APPLICATION NO.	FILING DATE	FIRST NAMED INVENTOR	ATTORNEY DOCKET NO.	CONFIRMATION NO.
10/560,204	12/08/2005	Masaaki Teramoto	10921.373USWO	5649
52835 7590 04/17/2009 HAMRE, SCHUMANN, MUELLER & LARSON, P.C. P.O. BOX 2902 MINNEAPOLIS, MN 55402-0902				
EXAMINER SAKELARIS, SALLY A				
ART UNIT		PAPER NUMBER		
1797				
MAIL DATE		DELIVERY MODE		
04/17/2009		PAPER

### Office Action Summary

**DETAILED ACTION**

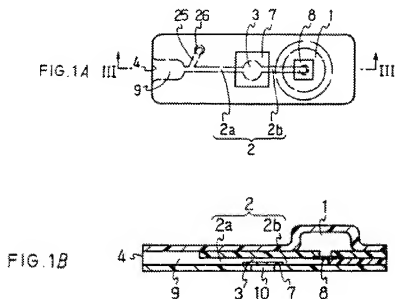
With regard to claim 1, Naka et al teach a suction device for sample analysis that comprises the below device:

The device comprises a flow path 2, a sample introduction port 4, a liquid reservoir for reserving the sample to be introduced into the flow path 9.

With regard to claims 2 and 3, the width of the liquid reservoir or pooling portion, 9 is about 4 times that of the drawing channel 2 (Col. 6 lines 9-12 and Fig 1A).

With regard to claim 5, figure 1b above depicts the provision of the reservoir and flow path on a plate member and the thickness dimension of 9 being larger than the thickness dimension of 2a.

With regard to claim 6, a width dimension of 9 near the intersection with 2a are equal or generally equal to each other.

With regard to claims 7 and 8, Naka teaches the 2 spacers (7 and 8) defining the thickness directions of both 9 and 2 with one located between the first and second plate members.
